REQUEST FOR PROPOSAL

RFP# 2026-PSCS-01

ADDENDUM 1

Solar Installation at Public Safety Building Project

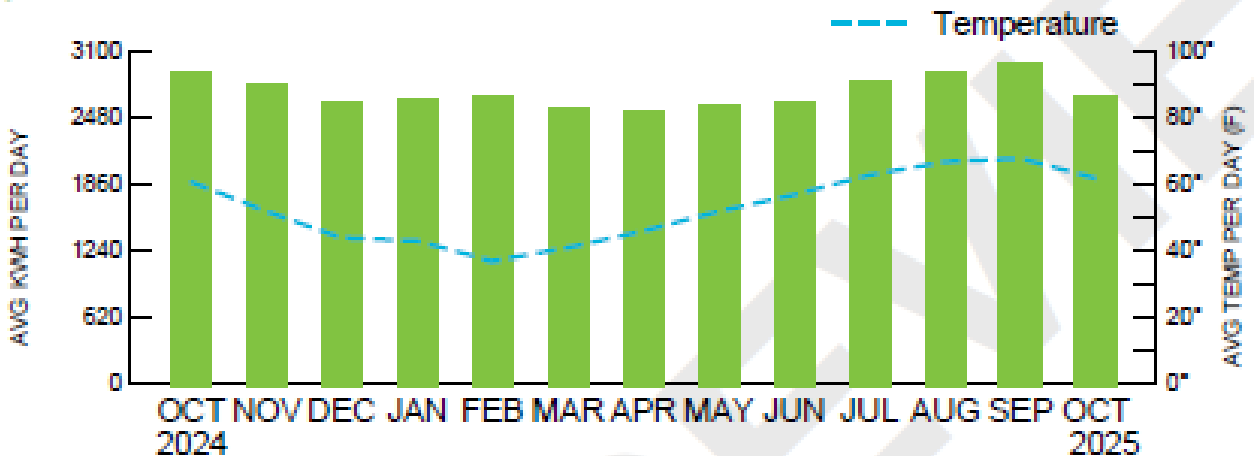
1. Where are the locations of the meter, ATS, and Generators compared to the main electrical panel.
A: A map will be produced with all necessary locations, including, meter, automatic transfer switches, and generators, as well as the location of the main building where the solar will be mounted and posted with this addendum.
2. Could you please share an electric power riser diagram for the building?
A: Yes, a copy of the electrical diagram will be posted along with this addendum.
3. What is the grant funded amount?
A: The grant amount for this measure is \$450,000.
4. Where will the solar be connected at the main building or the ATS/generator location?
A: It is our assumption that the connection will be made between the CTs and the Automatic Transfer Switch to avoid power interferences. This will be a discussion with the Generator/ATS Manufacturer and Puget Sound Energy (PSE).

2. Will the solar be able to be routed through the electrical room of the main building's distribution panel.

1. Are there extra conduits in either of the pads (the one with the electrical equipment on it, or the empty gen pad).

A: The solar could possibly be routed through the electrical room of the main building, however, the connection of the solar will likely be made at the ATS/CT location, **unless** the generator manufacturer indicates that the solar input will not interfere with the normal function of the ATS and Generator if it is landed in a subpanel in the main electrical room. The main electrical distribution panel is located by the ATS/Generator location (as seen on overview map).

A: There are (4) spare conduits in the Main Electrical Distribution Panel near the ATS, however, they are not connected to the main building's electrical room. Connecting the solar from the main building to the ATS location is around 100' away and will require location, asphalt cutting, and trenching of the conduit from the ATS/CT cabinet.
